At the meeting held in your office on April 3, 1987, it was agreed that Amphenol Corporation would review the groundwater contour maps for the former Amphenol facility in Broadview, Illinois. Attached for your review and information are copies of the revised maps as prepared by our consultant IT Corporation.

Project No. 303030

Transmittal
Revised Ground Water Contour Maps
Former Allied Corporation Facility
Broadview, Illinois

FIGURE I

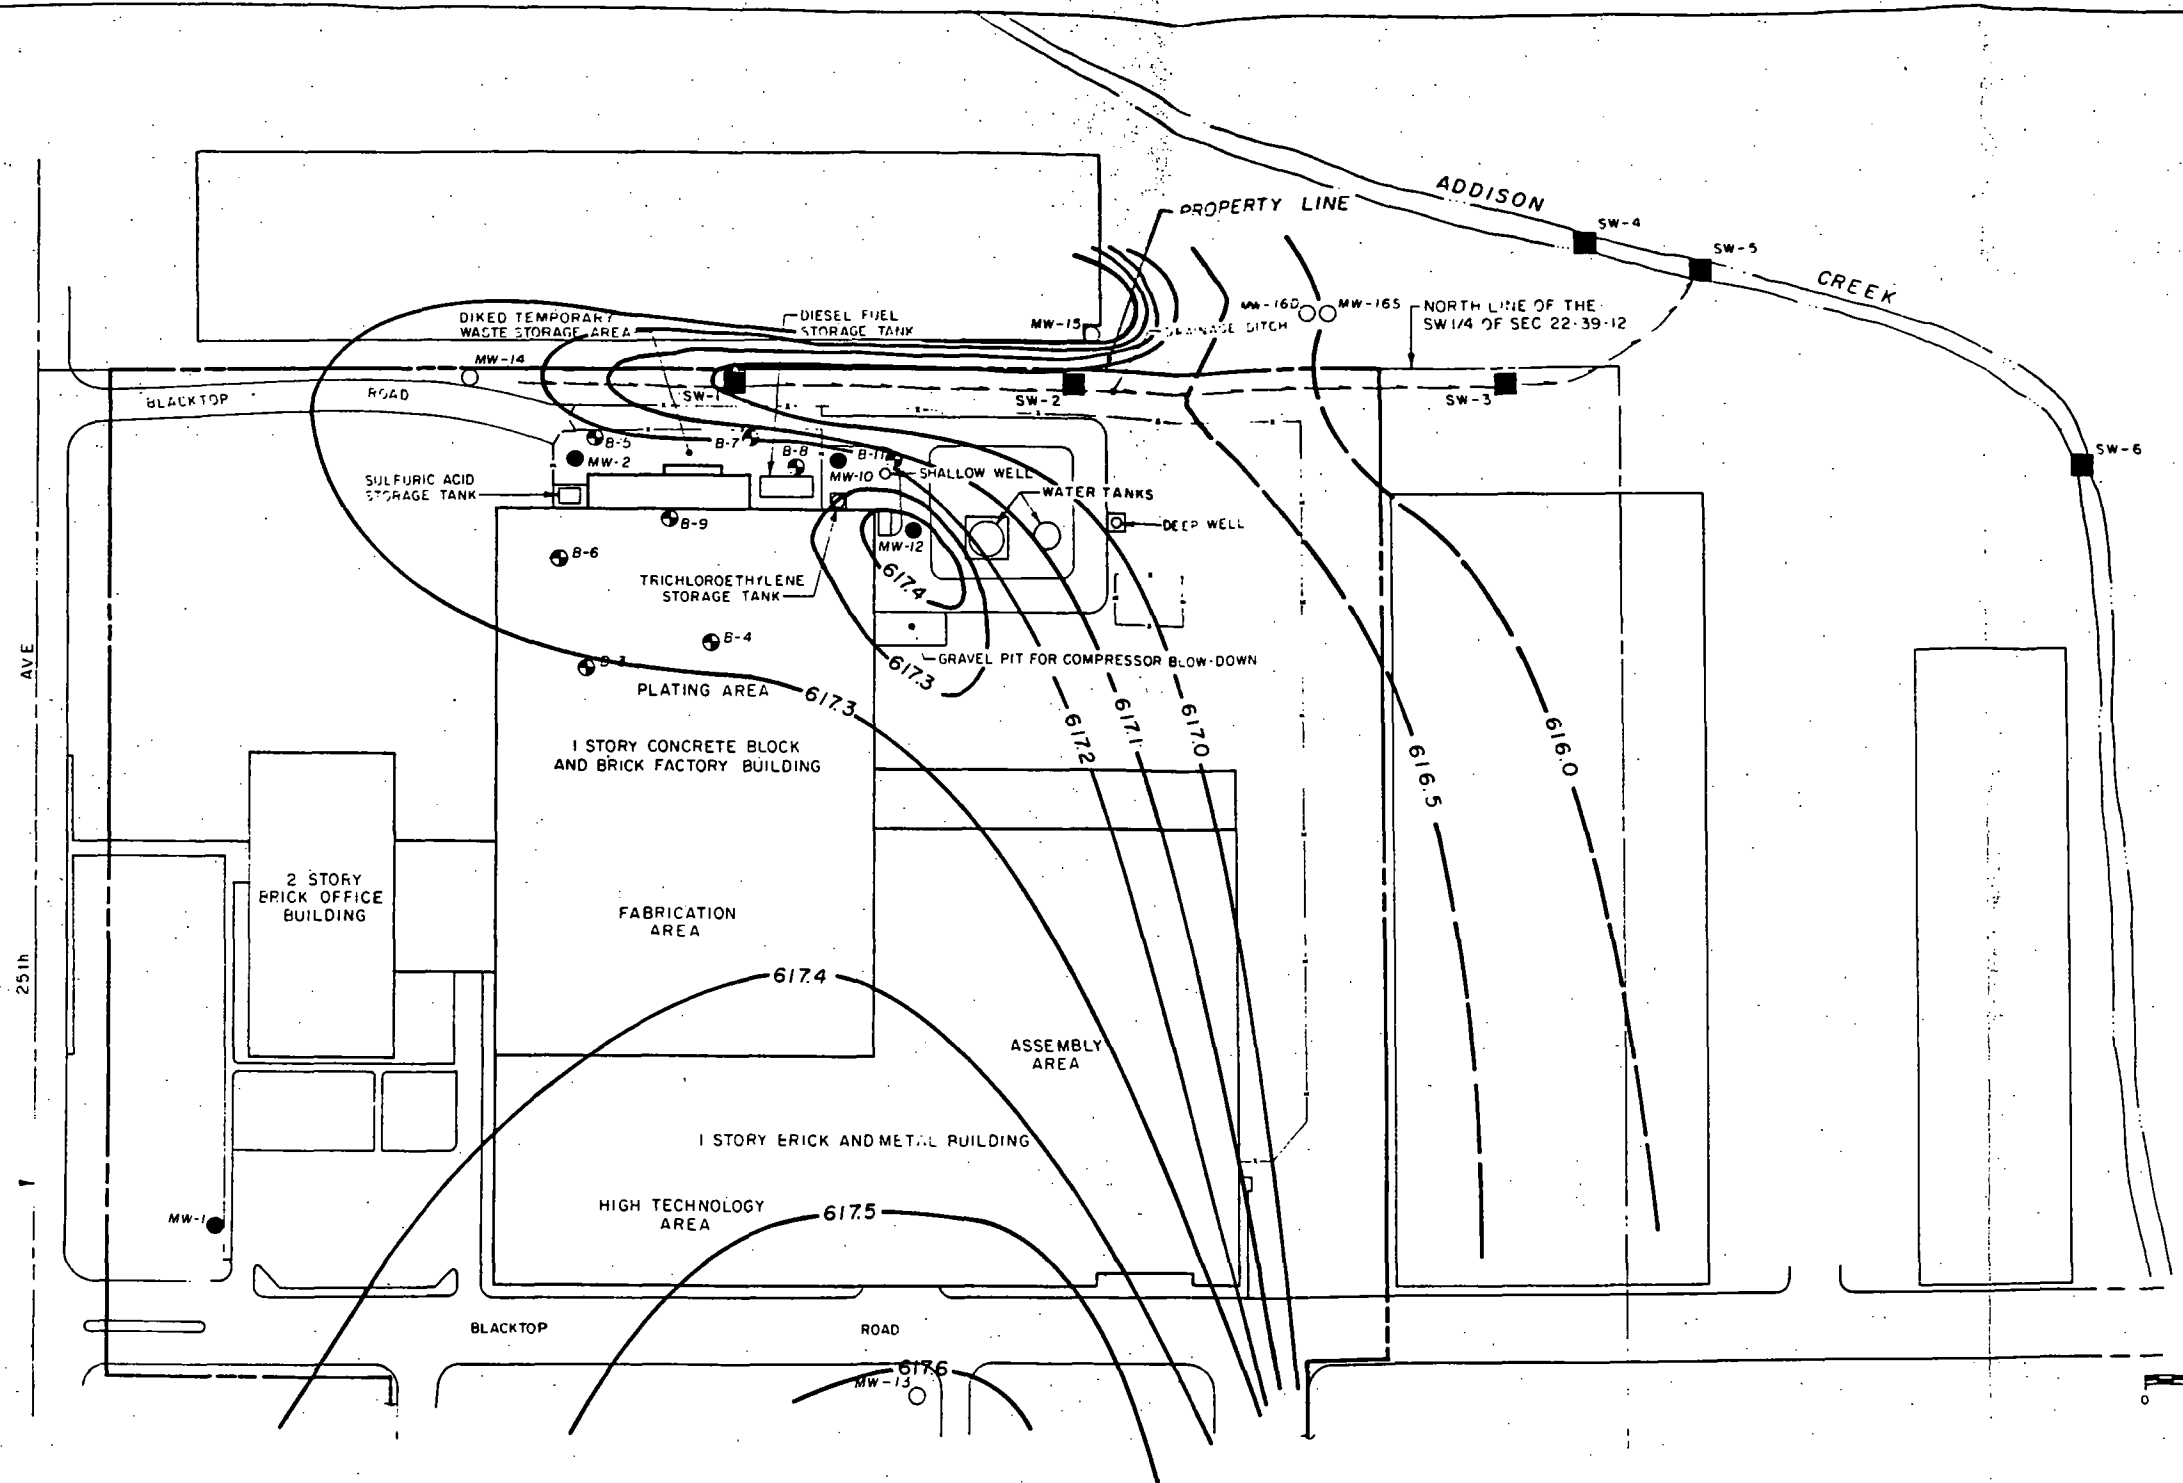
In general, I do not believe this reinterpretation of the data changes our perspective of site ground water flow. The finer contours do make the presence of a slight ground water "mound" become known in the vicinity of MW-12. General flow directions across the site are still primarily from the west and southwest flowing toward the east and northeast. The map from June 5, 1985 is, in my opinion, still the most representative and most accurate ground water contour map, due primarily to the fact that well No. MW-14 was still in use at that time and provides an indication of the impact of the drainage ditch north of the site on ground water flow toward Addison Creek. This map (Figure 1) also gives indications of a ground water flow component from the north-northwest as revealed in the vicinity of well No. MW-15. Such a regional flow component could potentially influence ground water quality in the vicinity of MW-16S more than flow from the area of MW-12 or the remainder of the plant site.

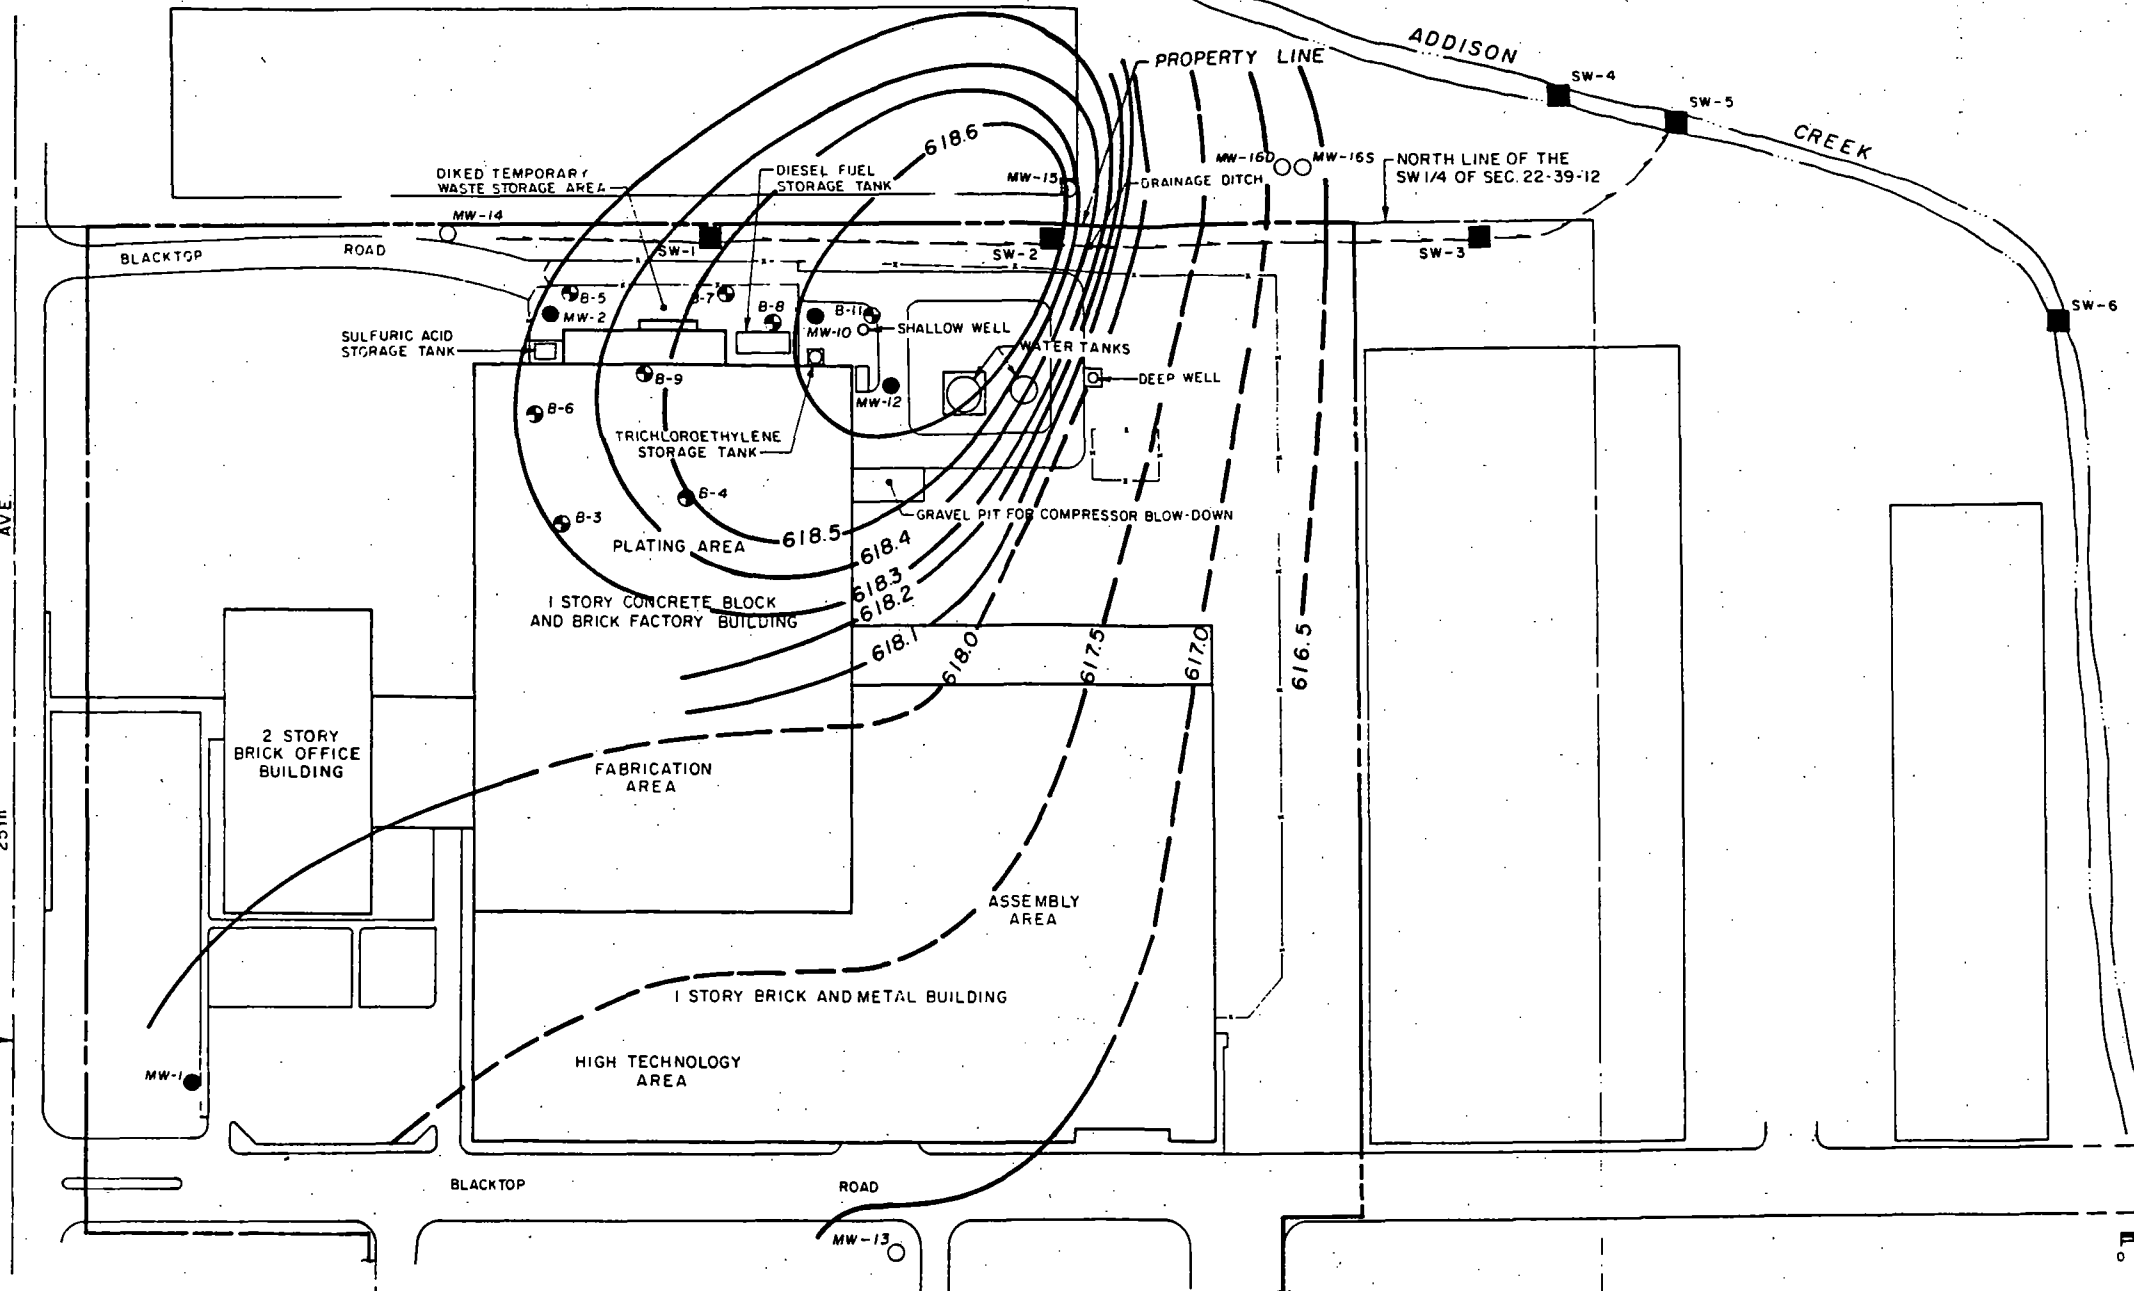
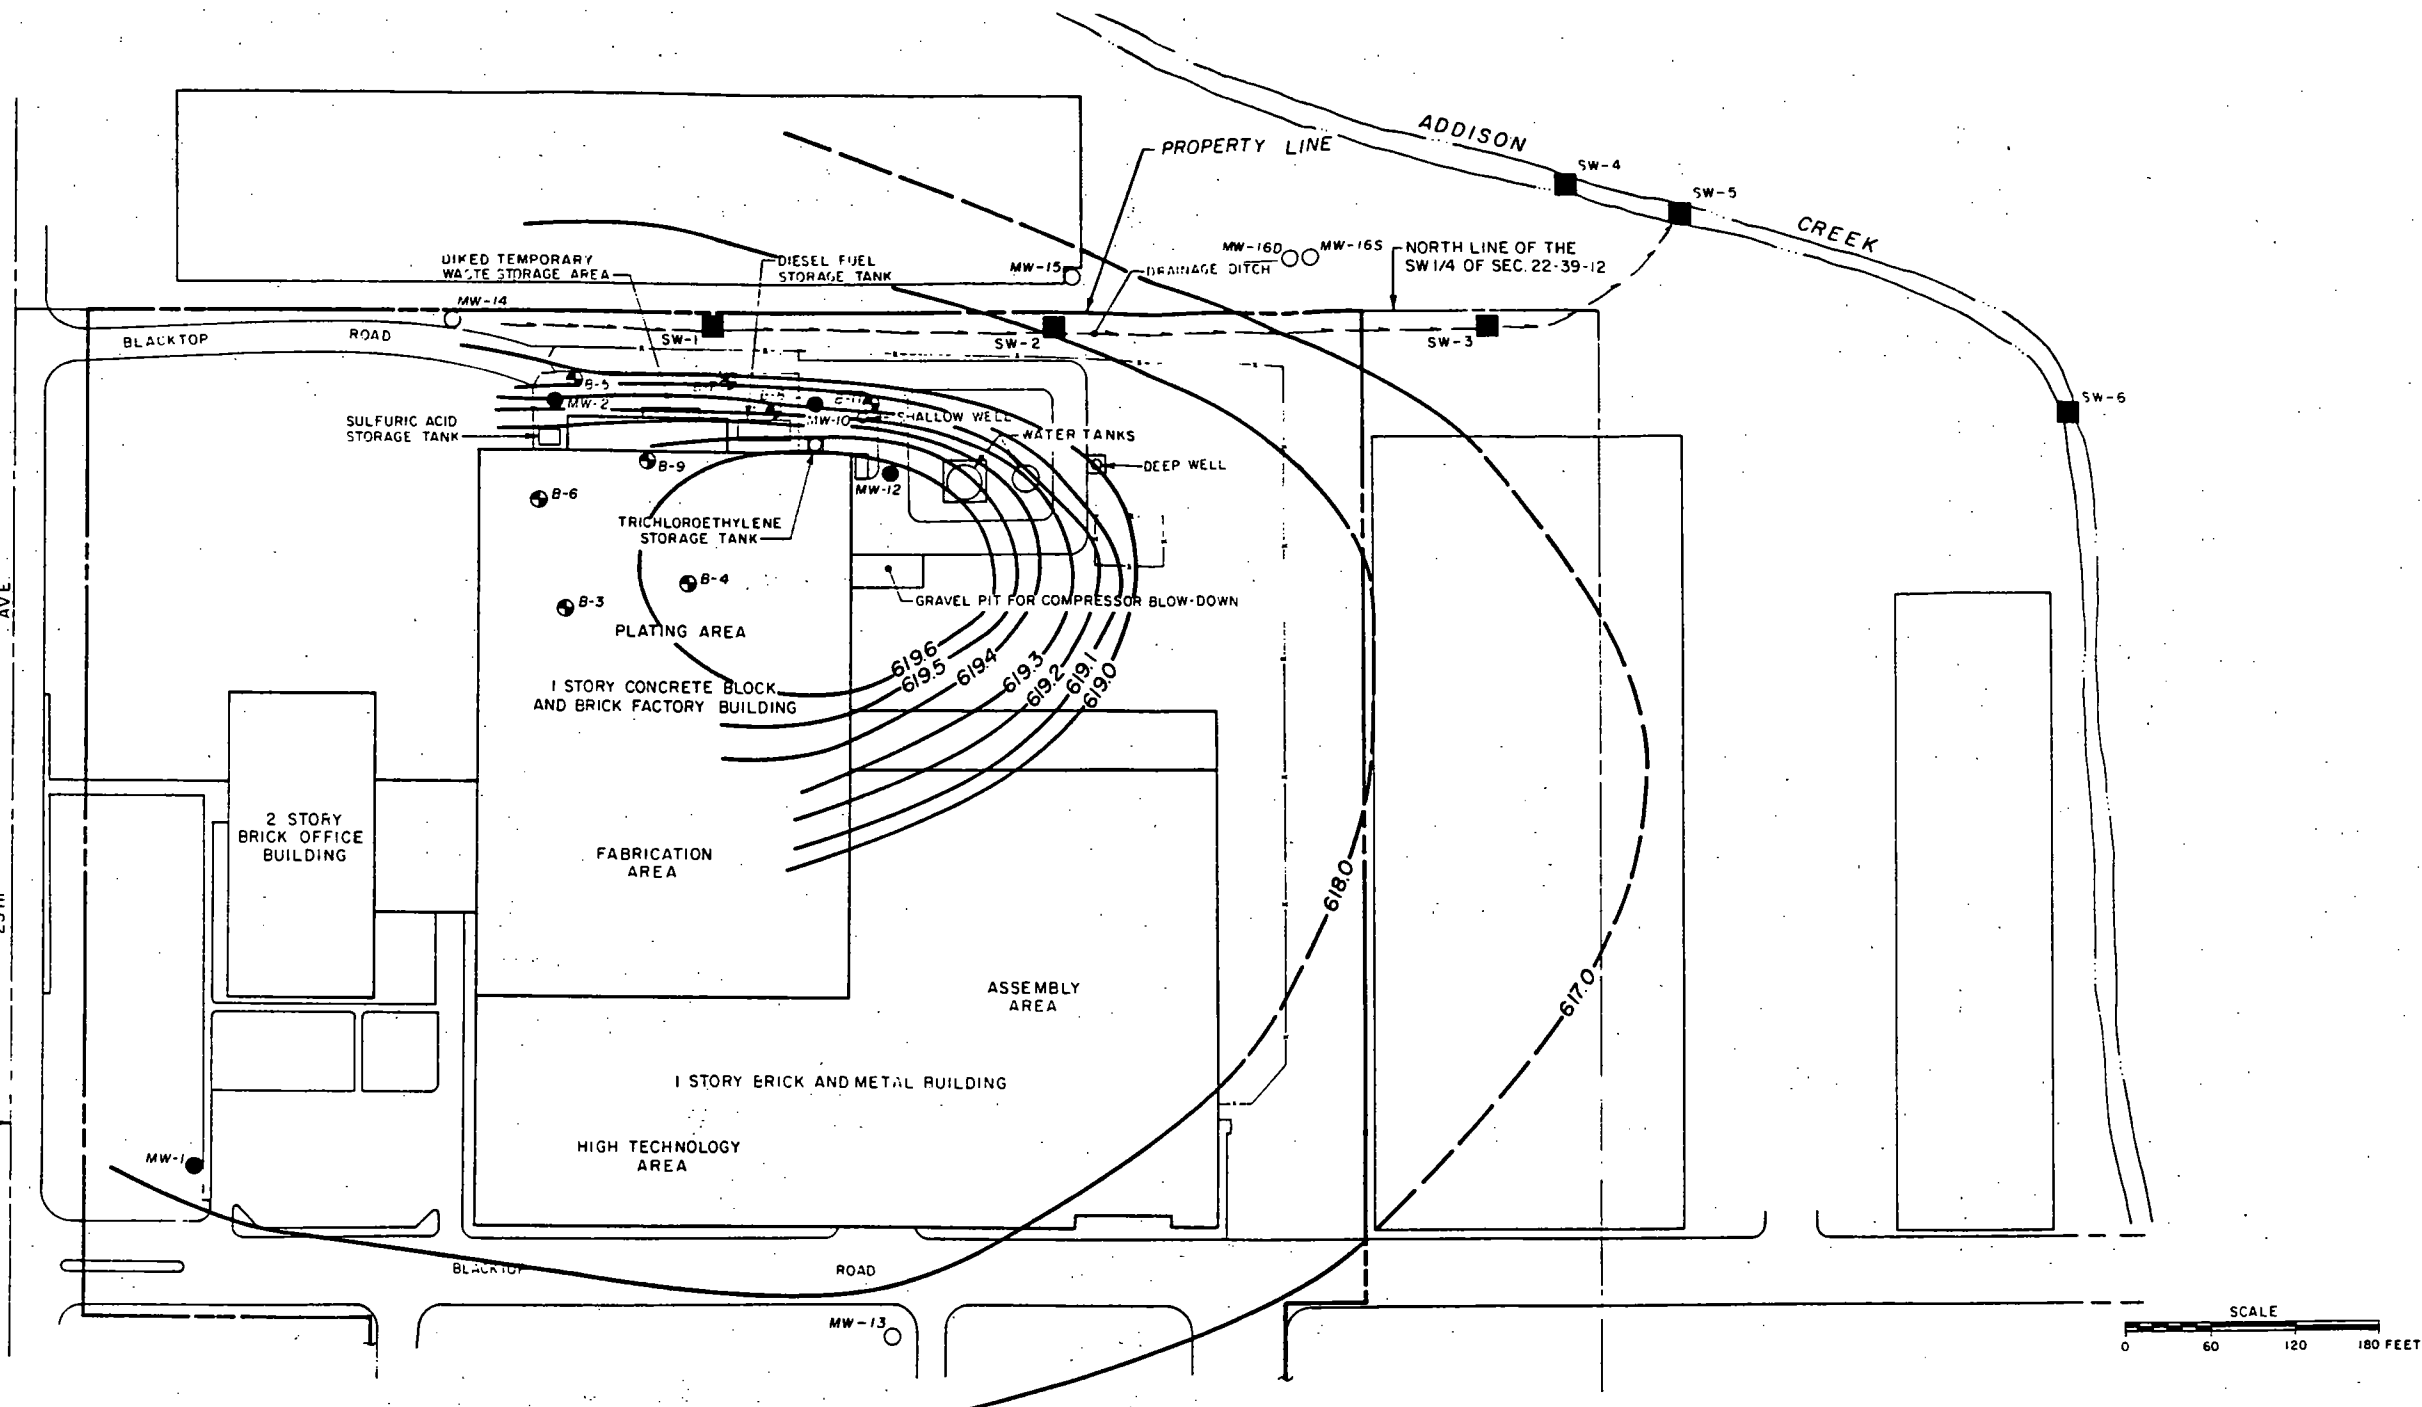
The maps prepared from the data obtained during the quarterly monitoring program (Figure 2 through 5) do not have the benefit of having data available from MW-14 and are thus limited to an interpretation of ground water flow which places more emphasis on the "mound" at MW-12 and its gradient toward MW-15 and MW-16S. This is what we believe to be the most correct interpretation of the direction of ground water flow based on the available data. In hindsight, Figures 2 through 5 would have benefited from having a ground water elevation measurement available from well No. MW-14. In all five figures, however, questions still remain in the interpretation of ground water flow from the north and its impact on flow in the vicinity of wells Nos. MW-15 and MW-16S. However, as we previously discussed, to answer these types of questions becomes more of a regional issue and would involve installation of more offsite wells. Figure 1, which benefits from the largest number of monitoring wells, gives strong indications of a flow component from the north, which along with the influence of the drainage ditch, indicates flow from the north-northwest is influencing well No. MW-16S more than flow from the plant area to the southwest.
